November 27, 1992

SUBJECT: SUSQUEHANNA STEAM ELECTRIC STATION  
DOCKET NO. 50-387  
LICENSE NO. NPF-14  
10CFR21 REPORT OF SUBSTANTIAL SAFETY HAZARD

**Figure 1**  
**Time to Boil vs. FPC Heat Load**

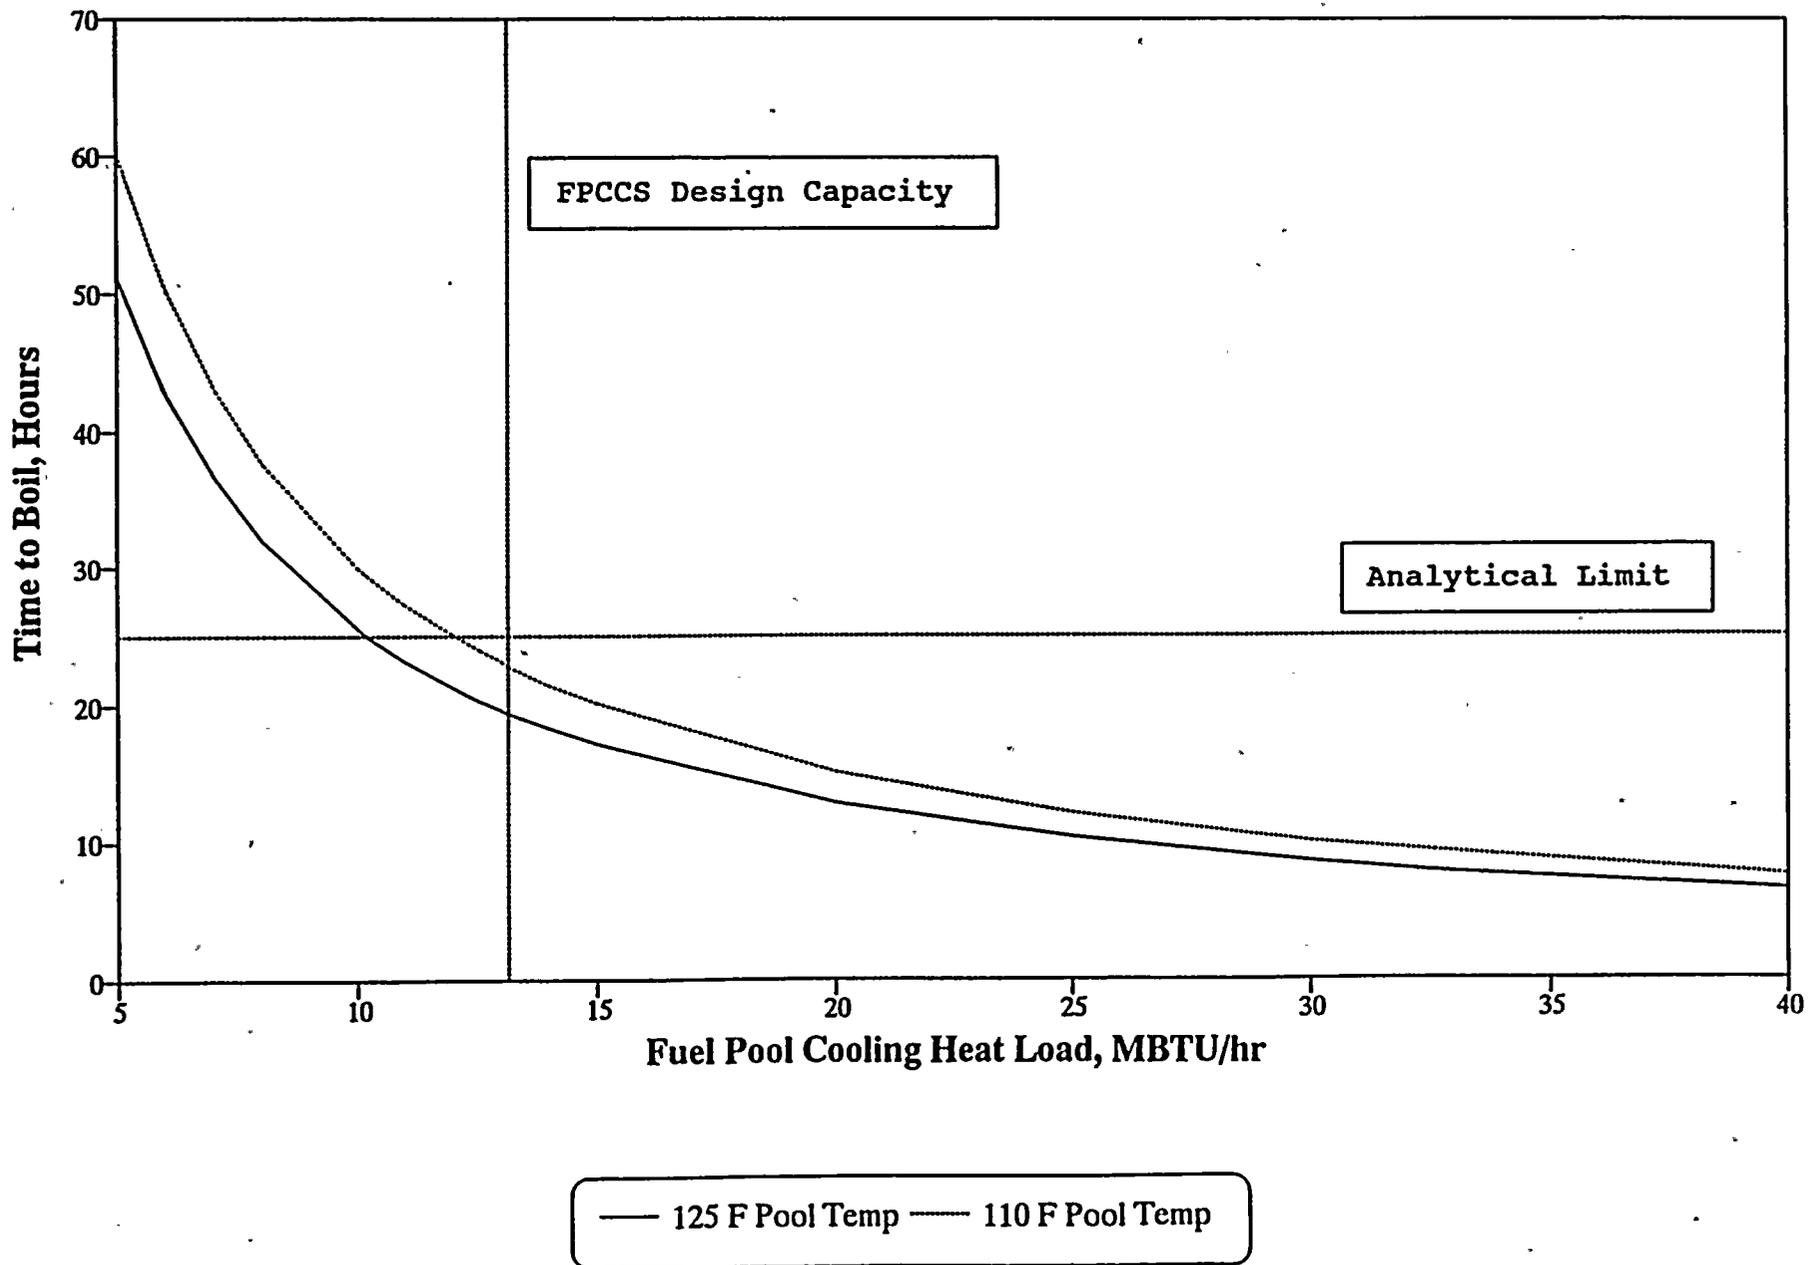
**CONCERN:** The maximum normal heat load in the spent fuel pool is presently higher than 9.79x10<sup>6</sup> BTU/hr and will also increase as a result of power uprate. The fuel pool will boil in less than 25 hours for any fuel pool heat load greater than 9.79x10<sup>6</sup> BTU/hr. (See Figure 1 from Calc M-FPC-009 attached).
